CITY OF AUSTIN
Board of Adjustment/Sign Review Board
Decision Sheet

CASE NUMBER: C15-2010-0134

ADDRESS: 12912 PARK DR

VARIANCE REQUESTED: The applicant has requested a variance to decrease the minimum side yard setback requirement of Section 25-2-492 (D) from 5 feet to 4.46 feet along the west property line in order to maintain a garage for a single-family residence in an "SF-2", Single-Family Residence zoning district.

1" encroachment

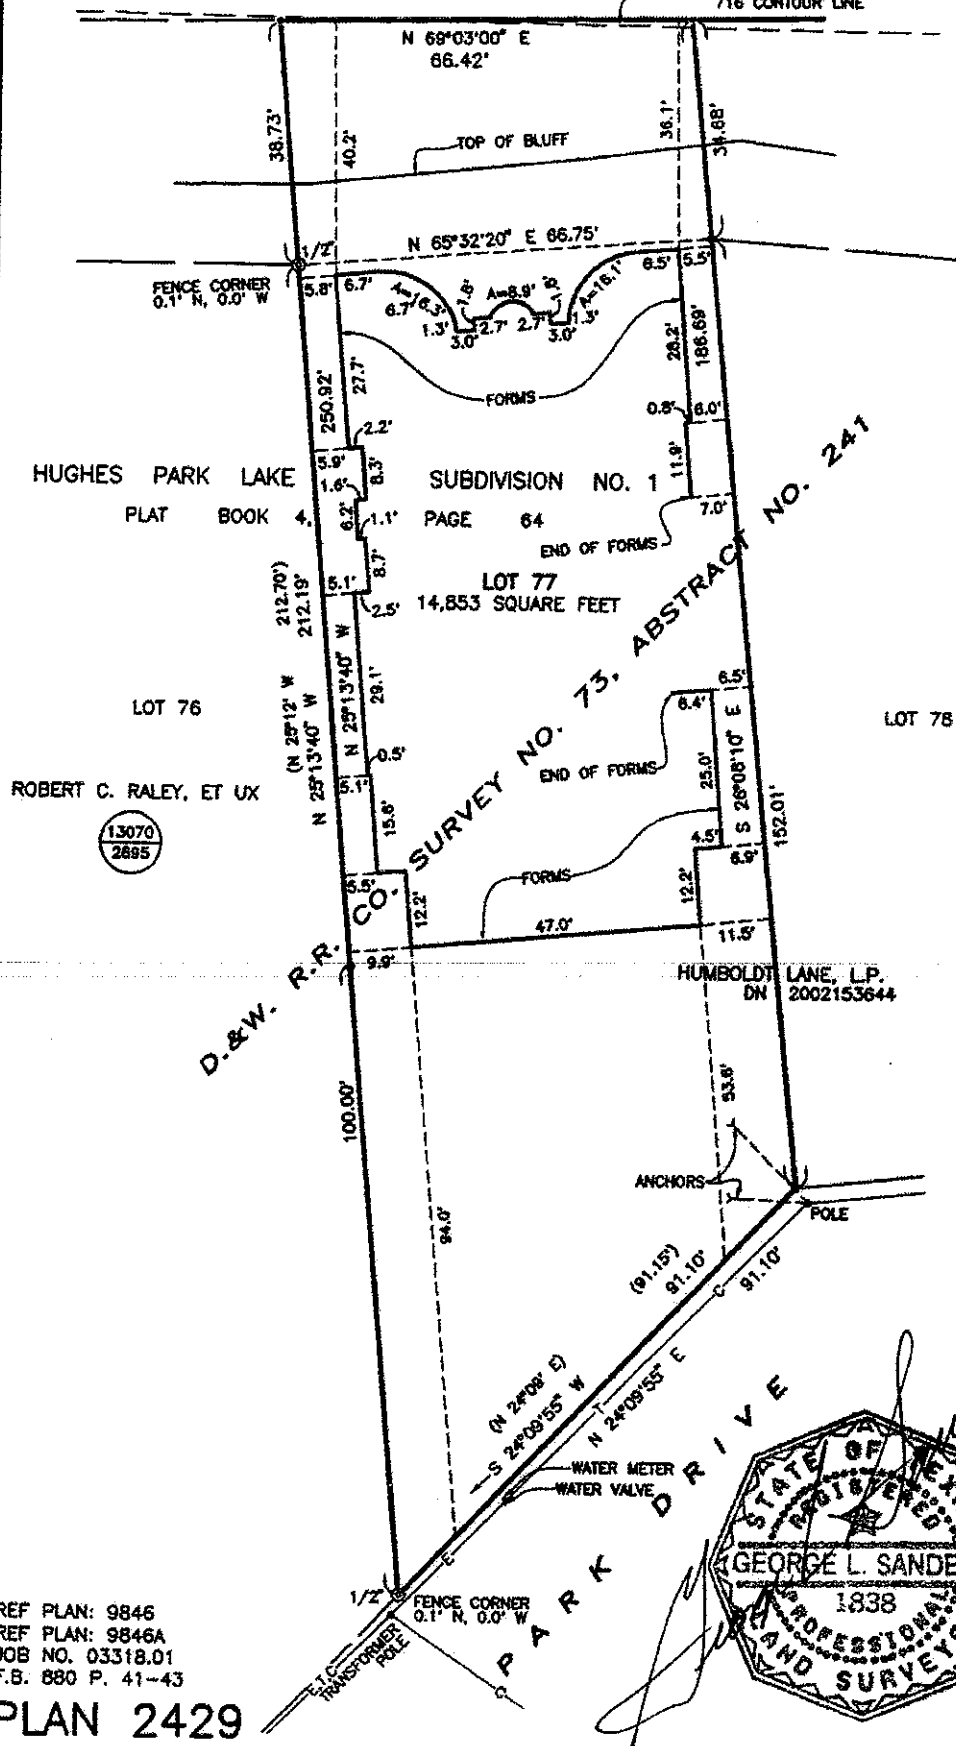
HOUSE

DECK

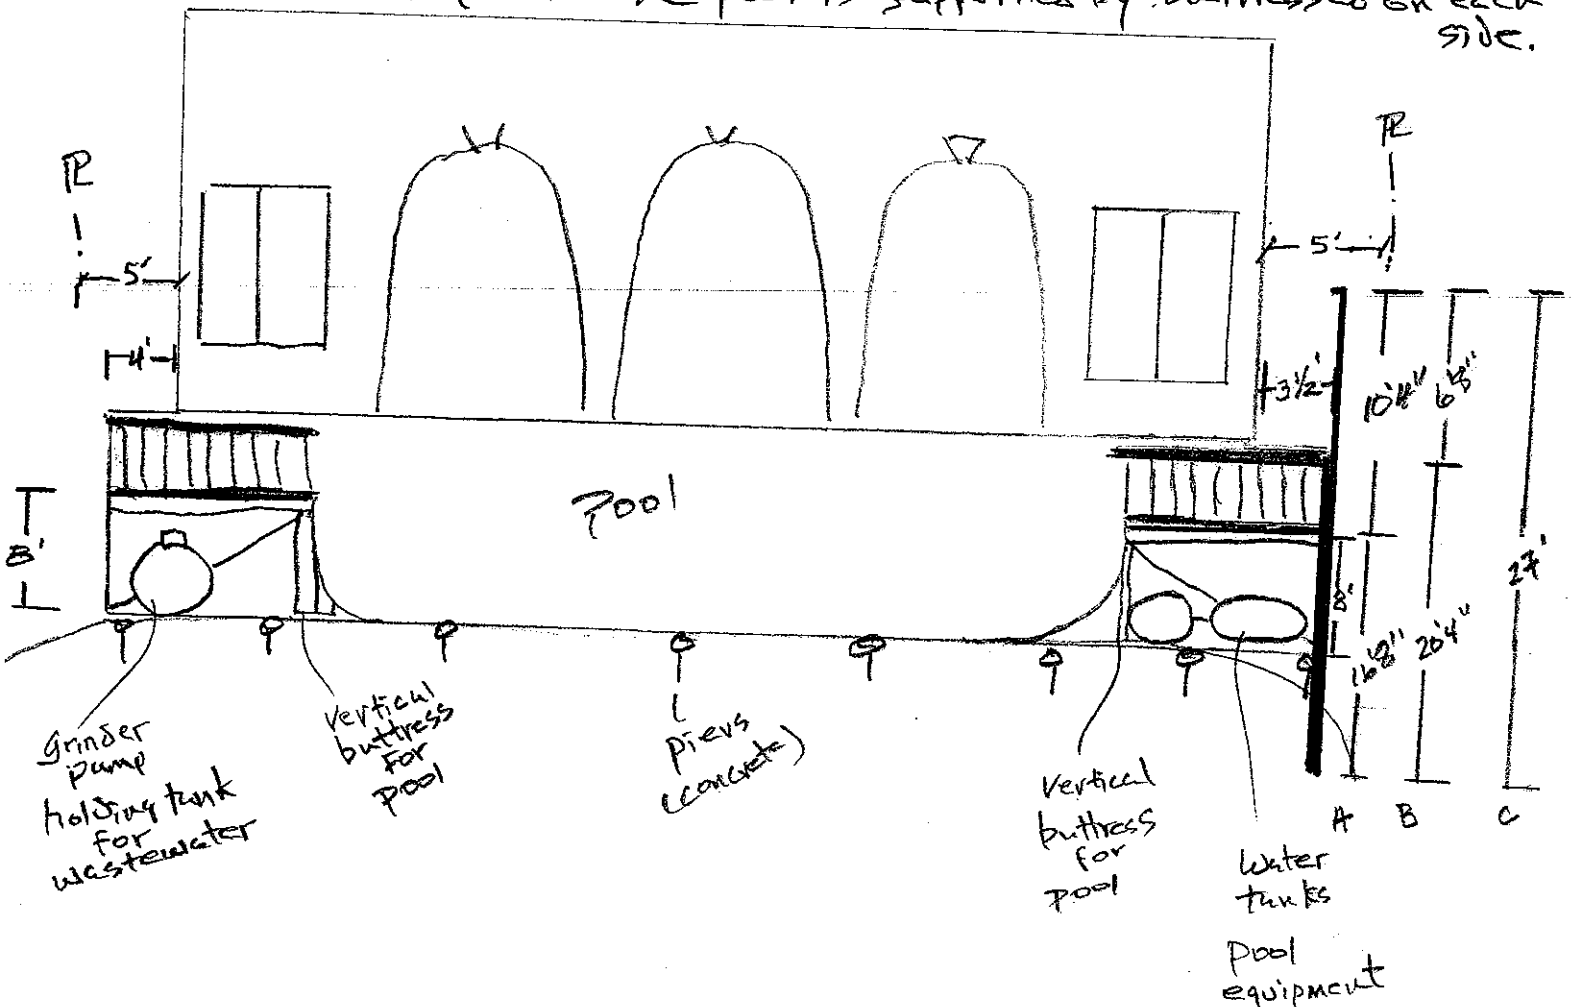
1. The deck extends into sideyard $3\frac{1}{2}$ -4'.
2. The deck is part of the landscaping/hardscape + covers pool equipment on the west side + wastewater package plant, including a grinder pump and wastewater holding tank on the east side.
3. The deck covers the structural support (vertical buttresses) for the pool, pool equipment + sewage equipment.
4. On the west the lot owner has constructed a 27' concrete, iron, wood + sheet-metal wall + fence. The concrete portion of the wall is 20'4" high, (B below); the fence/wall is 27' tall (C below); the wall and fence are 10'4" above the floor ~~level~~ level of the deck (A below). The deck is 8' above the ground.
5. The deck, pool equipment, + structural support are shielded by the concrete wall.
6. The pool, deck extended out over a bluff are supported by concrete piers. The pool is supported by buttressed on each side.

Snyder fence, lot 46

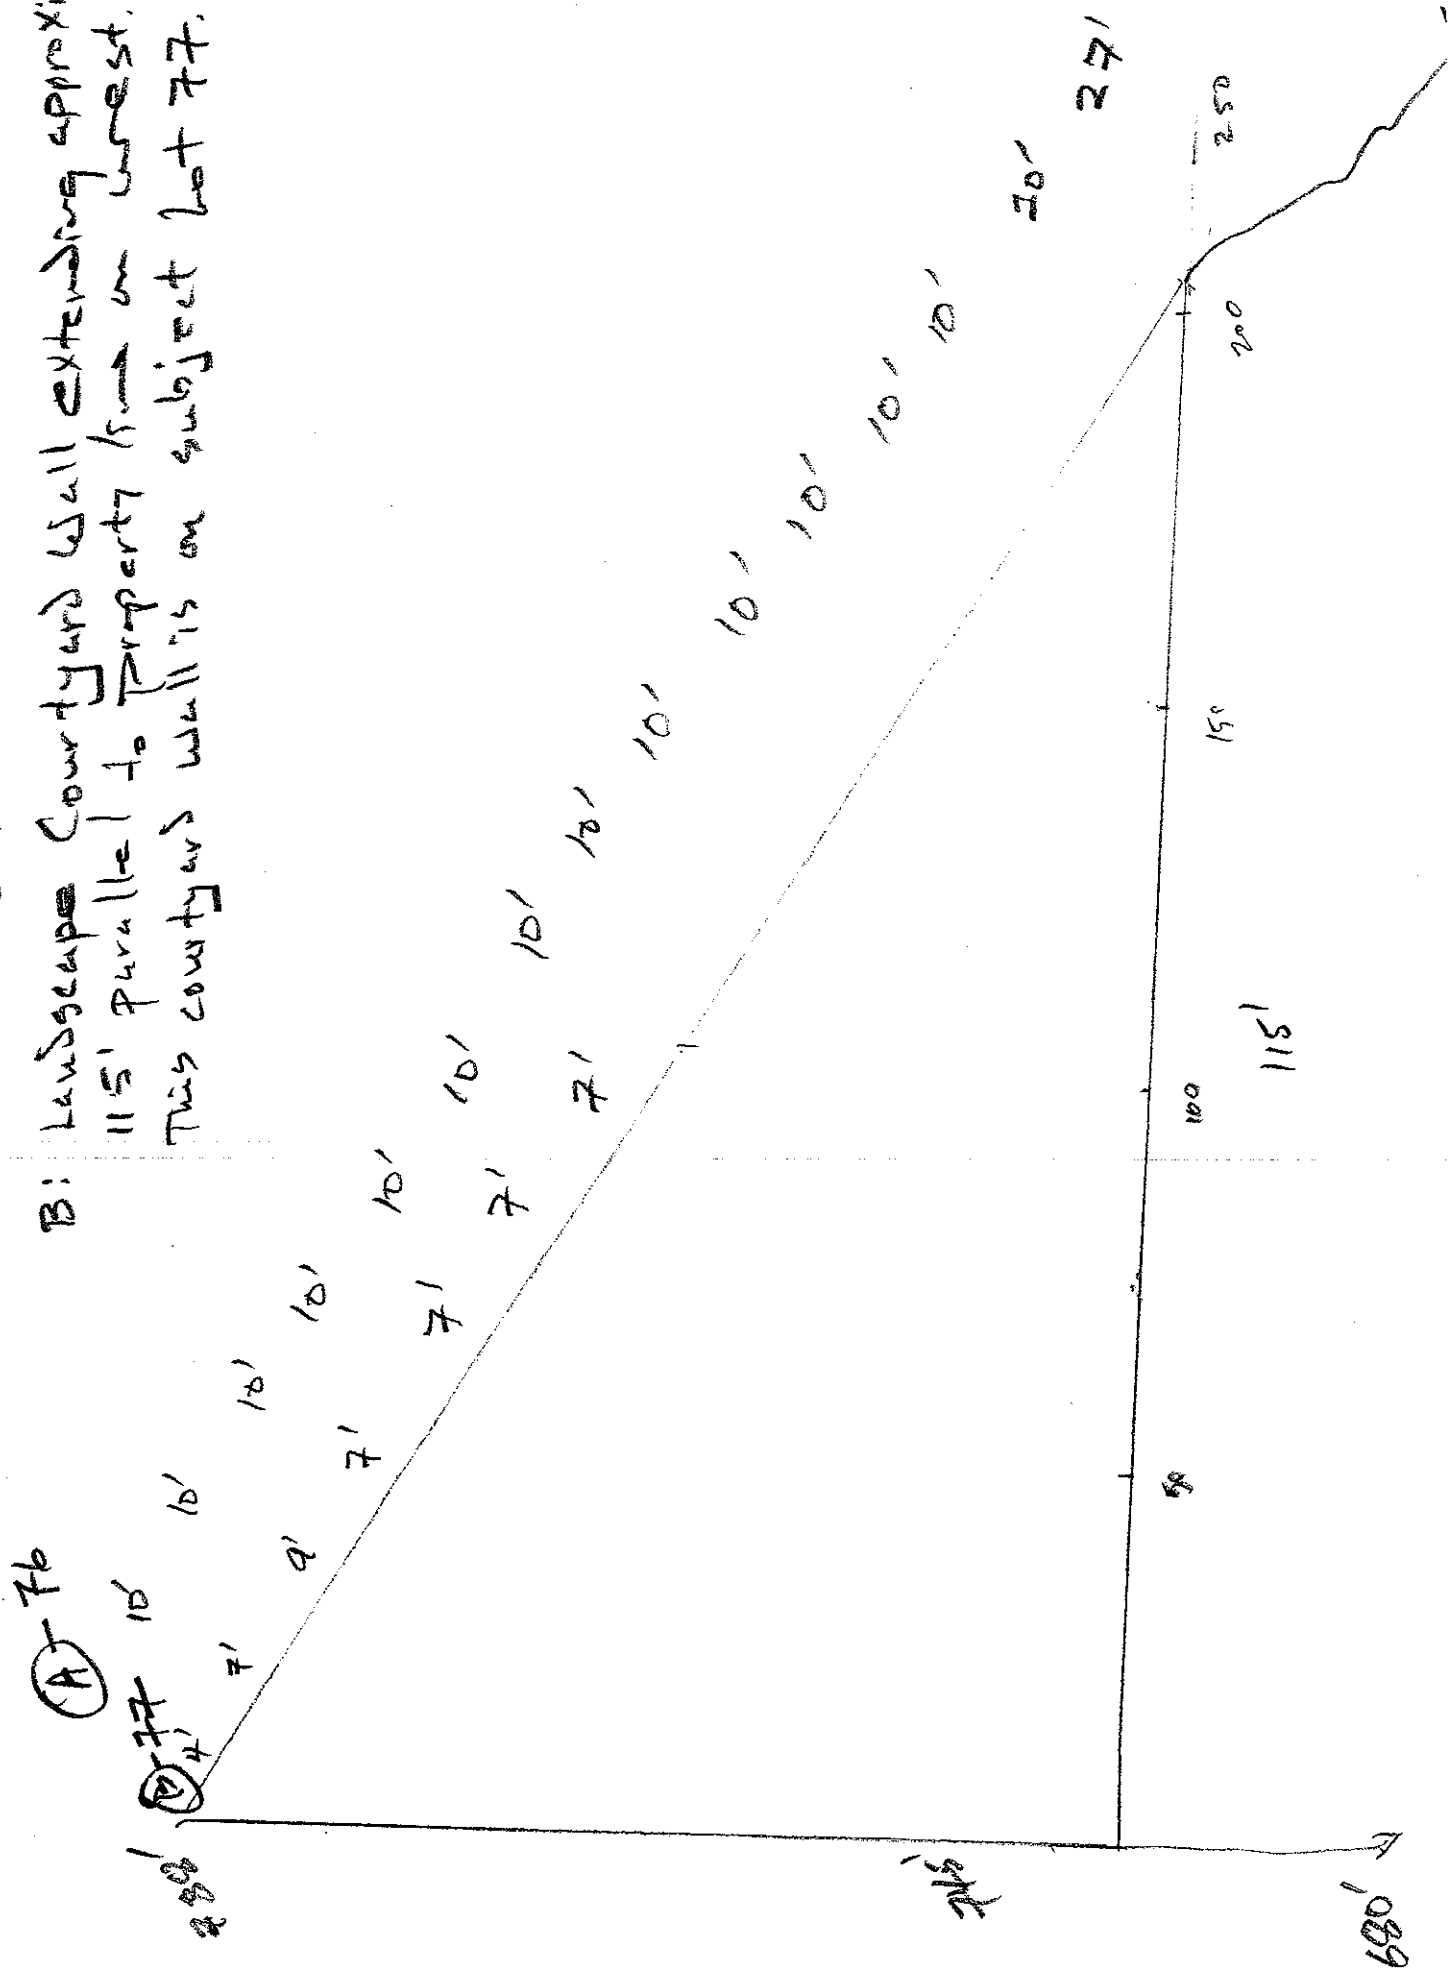
A: Fence/wall on lot 76 extending approximately 250' along property line

B: Landscape Courtyard Wall extending approximately 115' parallel to property line on west. This courtyard wall is on subject lot 77.

Fred's Wall getting started - Cut and Built to 15' September 2004 – NO PERMIT

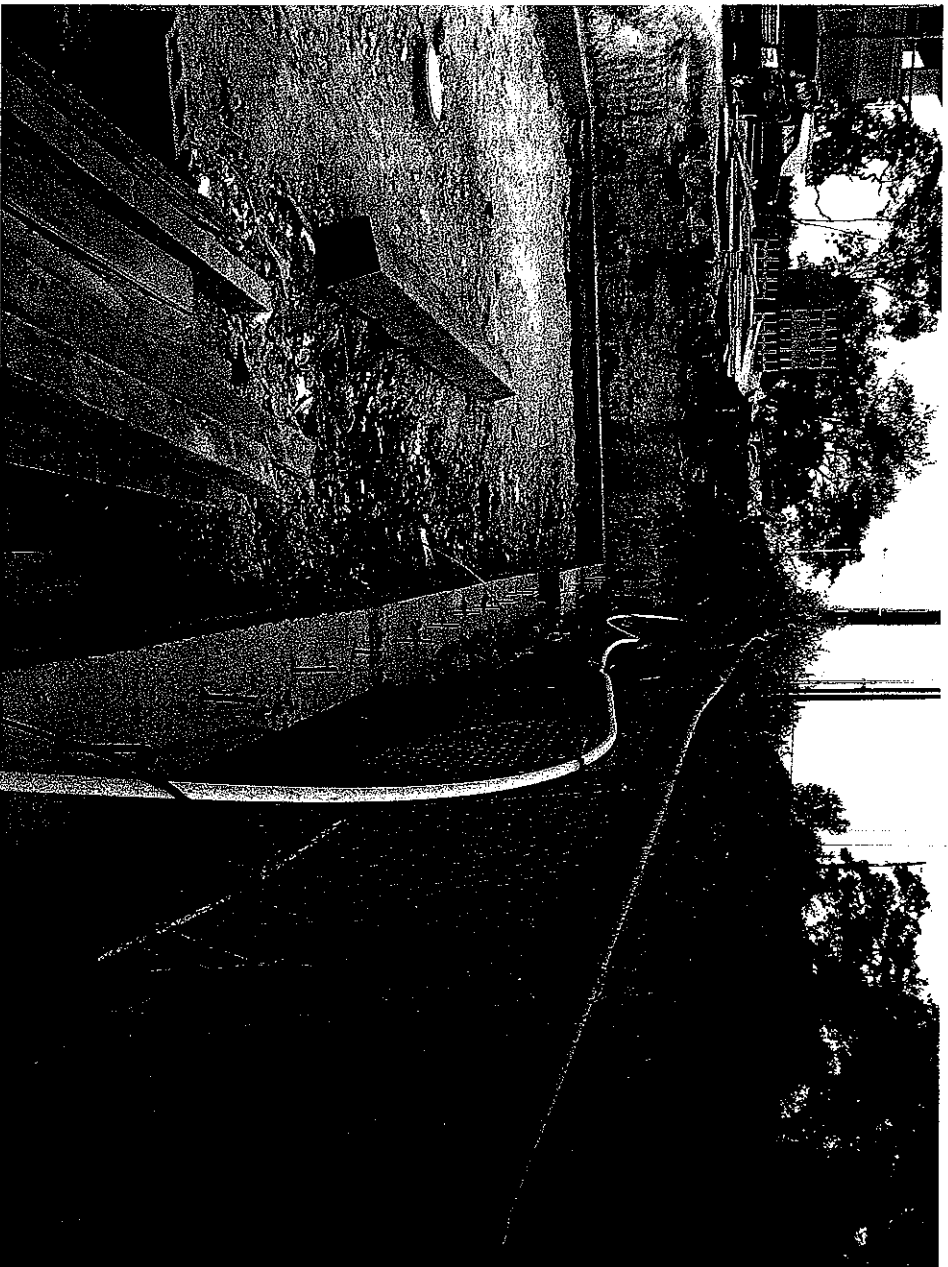
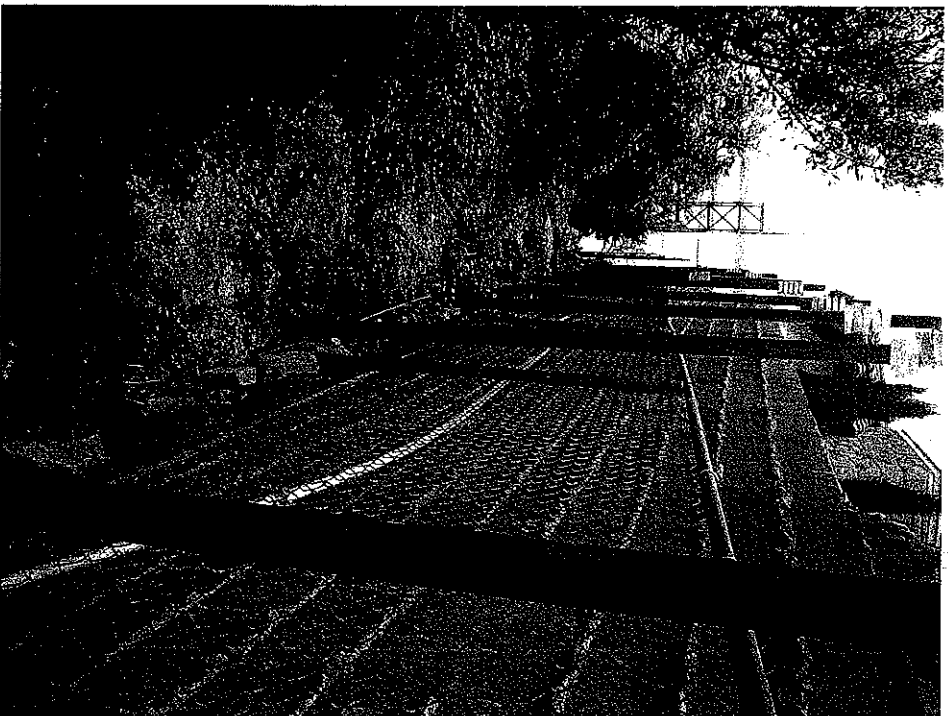
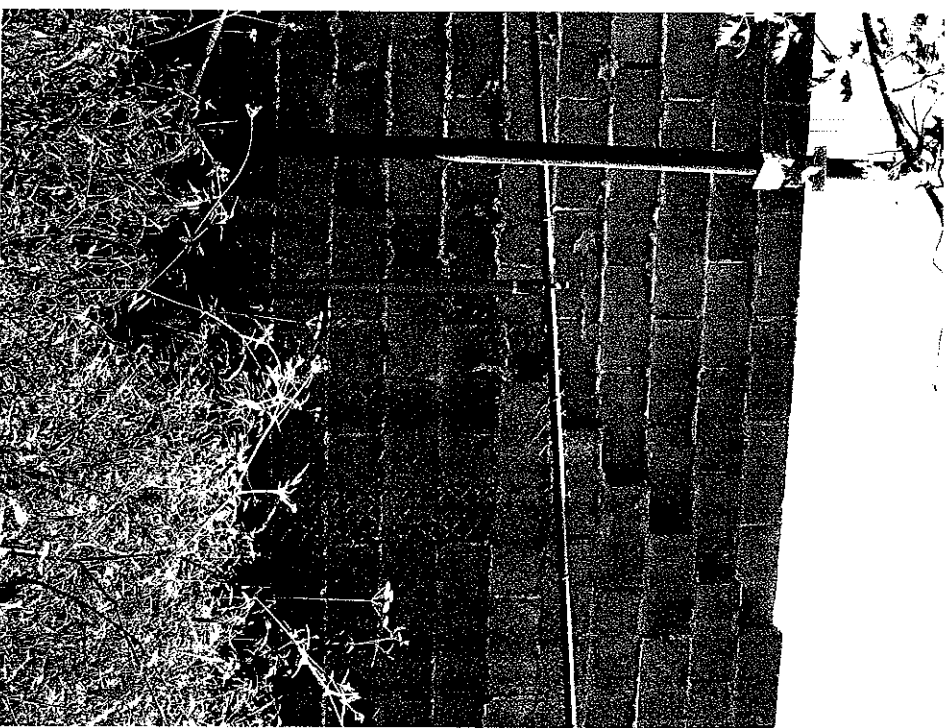
Unfinished on our side ☹️

Note gas line
above ground!!!

Our side of his wall

I'm 5'9" tall.

Left unfinished and jagged on purpose

Fred's two garages – before and after

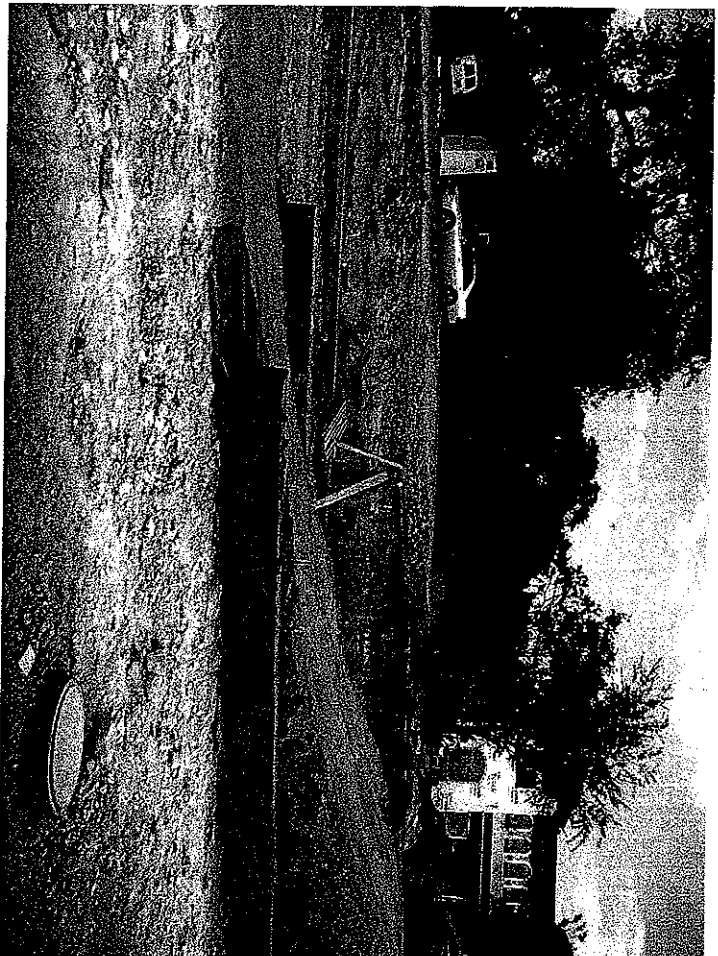
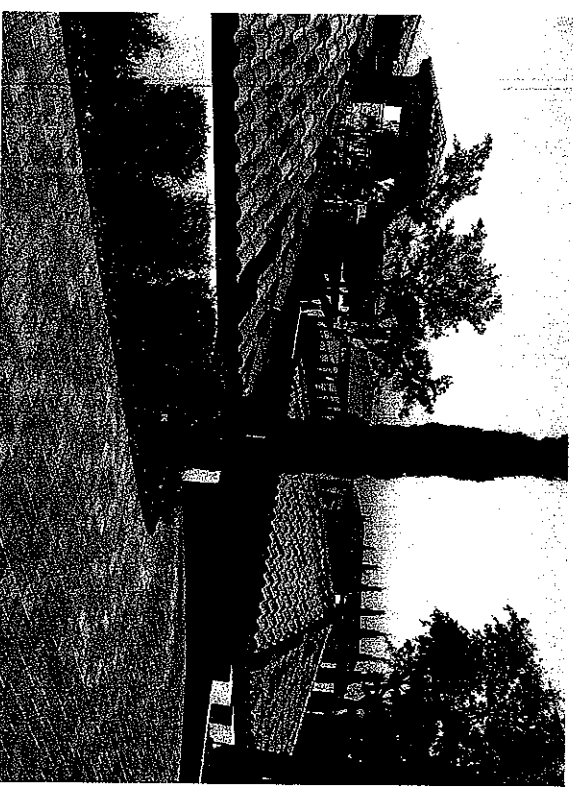
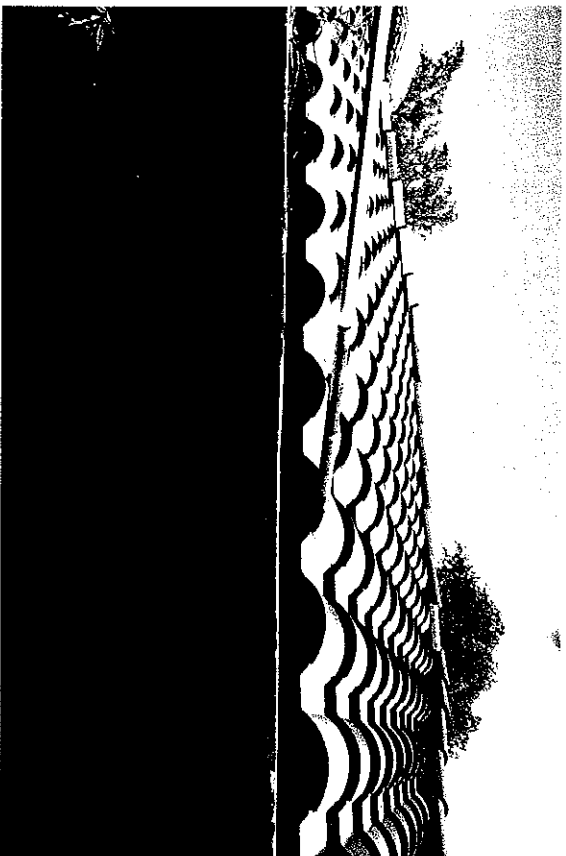
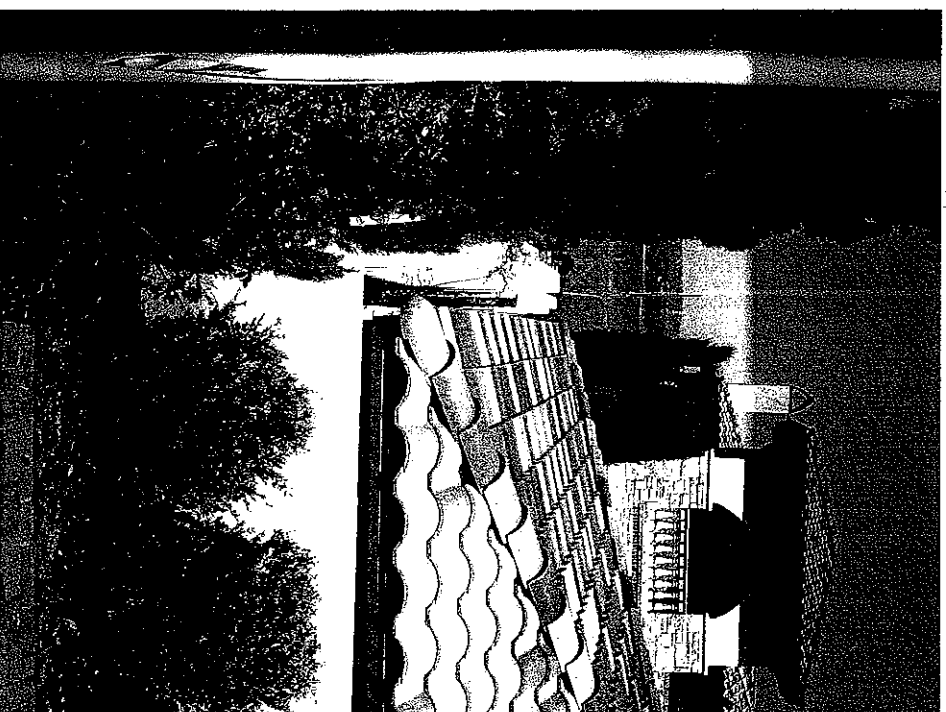
This was at 41%
impervious cover (max
45%)

Much more cover
now!! What %%?

Roof of his garage

Tiles of garage roof right next to property line

Roof line in setback; view from street
